6PK1140SF – 6PK1070+T38427

VAG 1.6 Diesel: CAYB & CAYC + Air-conditioning

Changes to VAG 1.6 diesel CAYB & CAYC engines affect models equipped with air conditioning, from October 2009 onward. Classic Multi-Ribbed V-belts replace earlier elastic belts.

Fig. 1

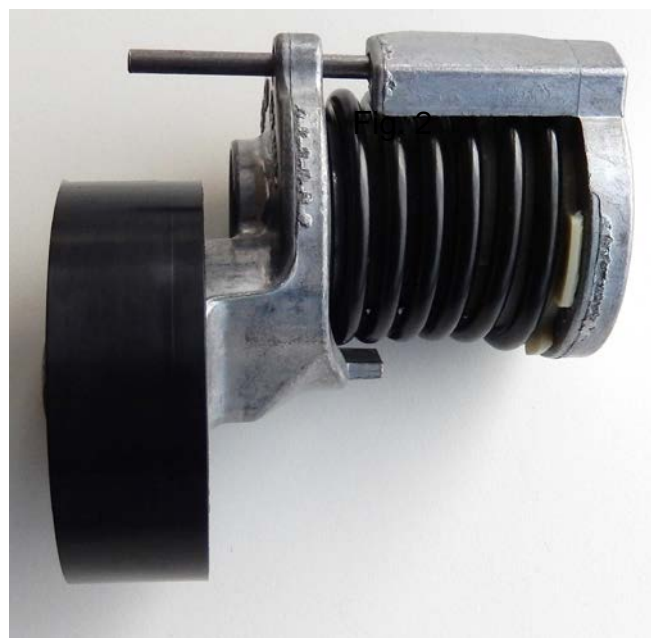
The Gates range includes Stretch-Fit™ belts for earlier applications that have not yet been adapted. Installation instructions and details about the correct tools required are printed on the inside sleeves and are also available from the online catalogue. Fig. 1 shows part of the initial procedure.
